**ADDENDUM  
NO. 01**

**Carmel Life & Learning Center Interior Finishes Remodel 2023**  
515 East Main Street  
Carmel, IN 46032

ADDENDUM NO. 1

Carmel Life and Learning Center – Fall 2022 Remodel Updates

### DRESSING ROOM ARCHITECTURAL DEMOLITION PLAN

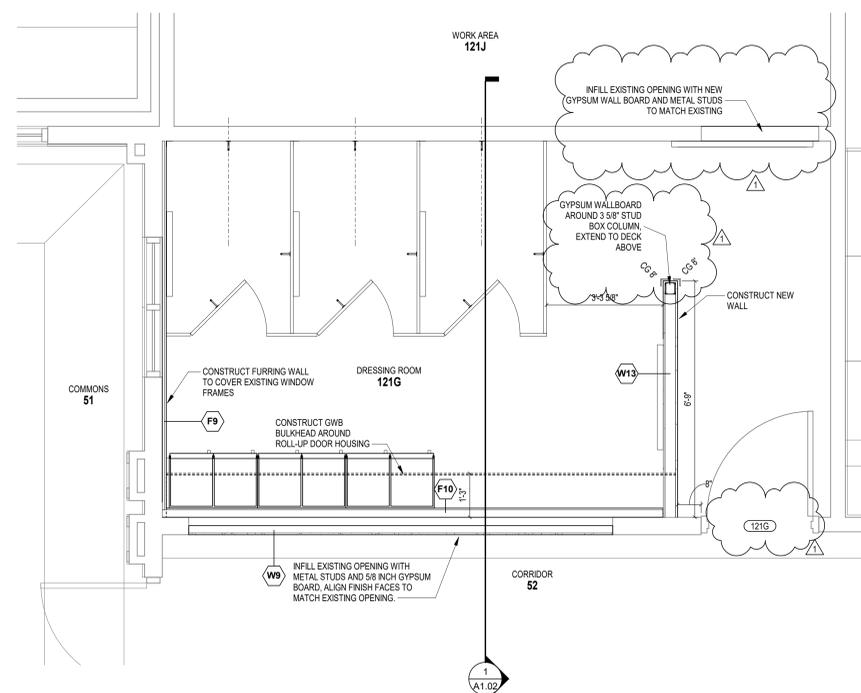
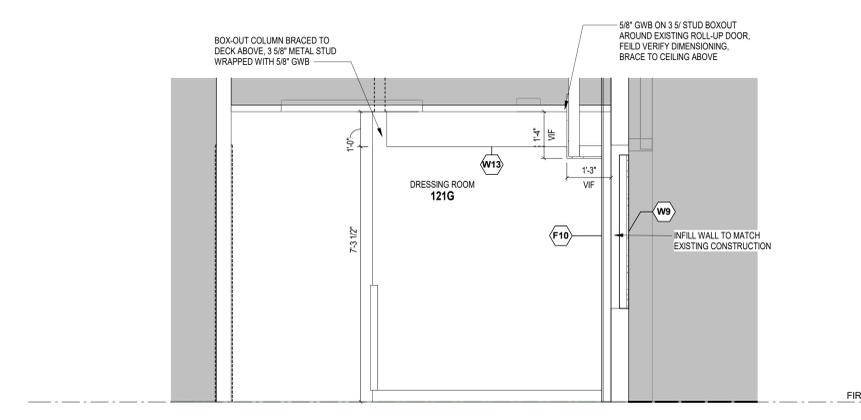
A. Dressing Room Demolition and Lighting Plan: Relocate existing light fixture one grid space to right/east away from new wall conflict.
